RE: Sedat #3A UIC Permit - Request for Clarification and Additional Information

Attachment L
Construction Procedures
Sedat #3A Injection Well

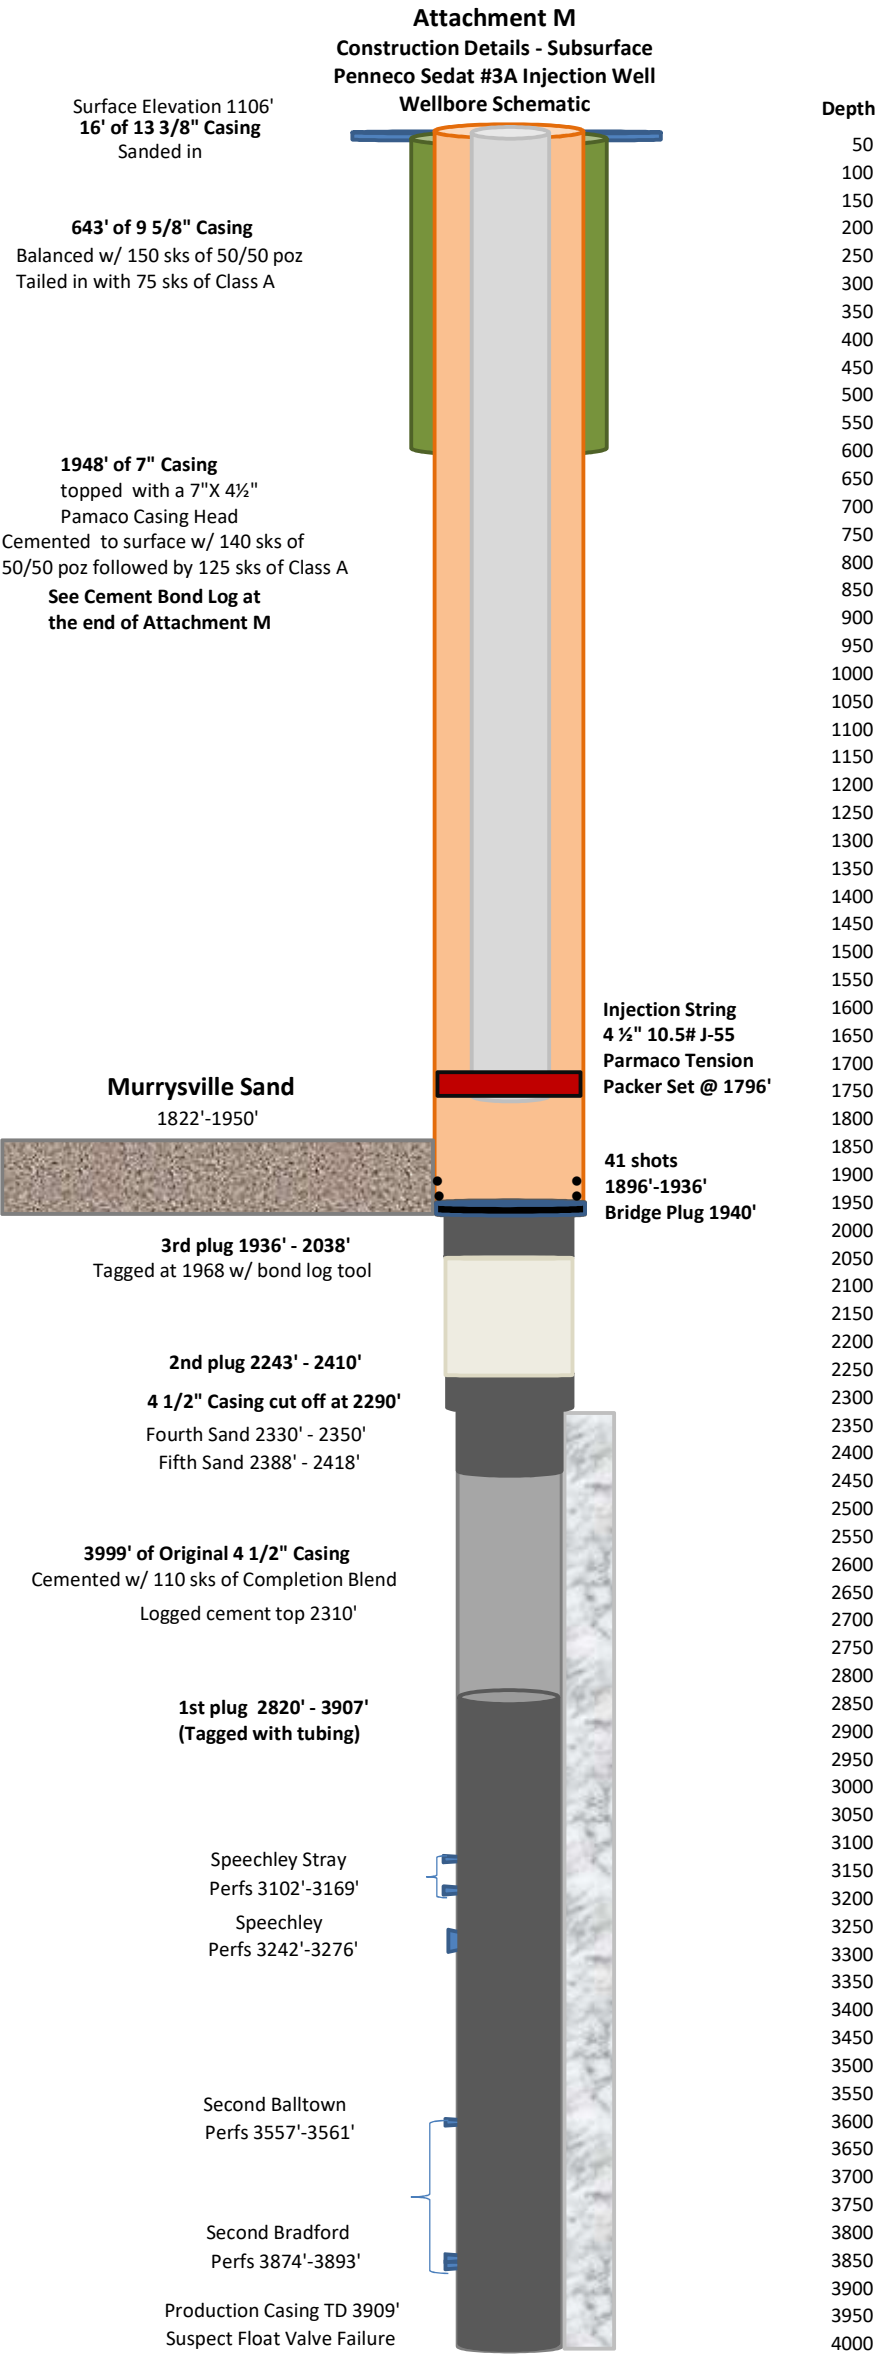
- 2) The difference in the referenced packer depths must have been related to the length of the packer which is 56¼". One was probably referencing the top of the packer and the other likely the bottom. Attachment L (attached) has been changed to match the packer depth on the diagram and include the length of the packer (1,796'). I noticed another discrepancy in the Attachment G (attached) narrative relating to the packer depth and changed it accordingly to read *approximately 1,800'*. I also changed the Murrysville Sand depth (1,822'-1,950') on the Attachment M diagram (attached) to better reflect the full sand body as detailed by the gamma.
